**ITEM 45. TRAFFIC TREATMENT – CONTINUOUS FOOTPATH TREATMENT
PEDESTRIAN CROSSING RAISED THRESHOLD AND TIMED
PARKING – PRIMROSE AVENUE ROSEBERY**

TRIM RECORD NO: 2017/213247

Proposed Angled Parking - Primrose Avenue, Rosebery

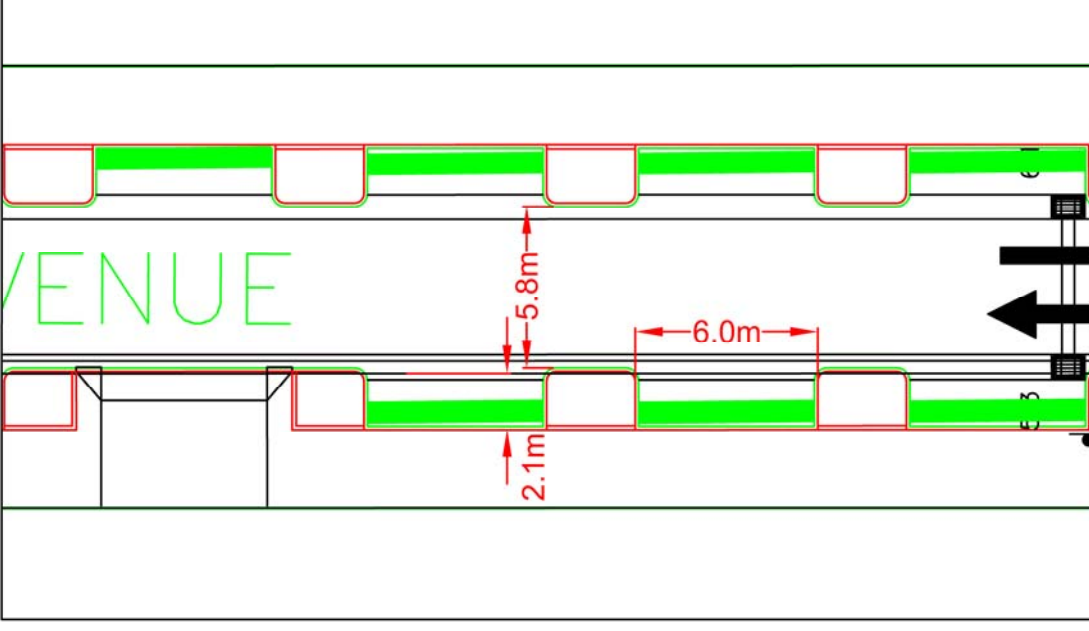
- (I) Eastern side, between the points 15.8 metres and 24.8 metres north of Crewe Place, as “Disability Parking Only and “60° Angle Parking, Rear to Kerb”;

- (J) Eastern side, between the points 24.8 metres and 136.6 metres north of Crewe Place, as “2P 8am-8pm” and “60° Angle Parking, Rear to Kerb”;
- (K) Eastern side, between the points 136.6 metres and 155 metres north of Crewe Place, as “No Stopping”;

The new road is a two way street, 6.3 metres wide and all parking spaces are provided in indented parking bays. There is 60° angle parking proposed adjacent to the new park to improve availability and accessibility for visitors to the park. This includes the provision of two disability parking spaces adjacent to the park.

Proposed Parallel Parking -
Primrose Avenue, Rosebery

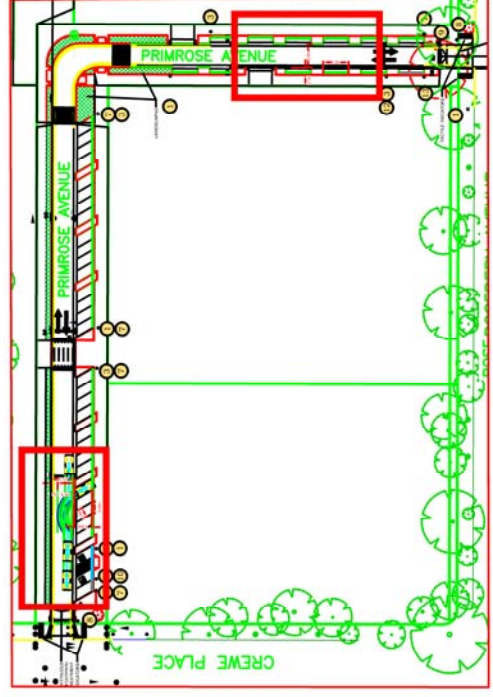
- (N) Southern side, between the points 23 metres and 78 metres west of Rosebery Avenue, as “2P 8am-8pm”;
- (O) Southern side, between the points 78 metres and 110 metres west of Rosebery Avenue, as “No Stopping”;

- (P) Northern side, between the points 0 metres and 13 metres west of Rosebery Avenue, as “No Stopping”;
- (Q) Northern side, between the points 13 metres and 68 metres west of Rosebery Avenue, as “2P 8am-8pm”; and
- (R) Northern side, between the points 68 metres and 110 metres west of Rosebery Avenue, as “No Stopping”.
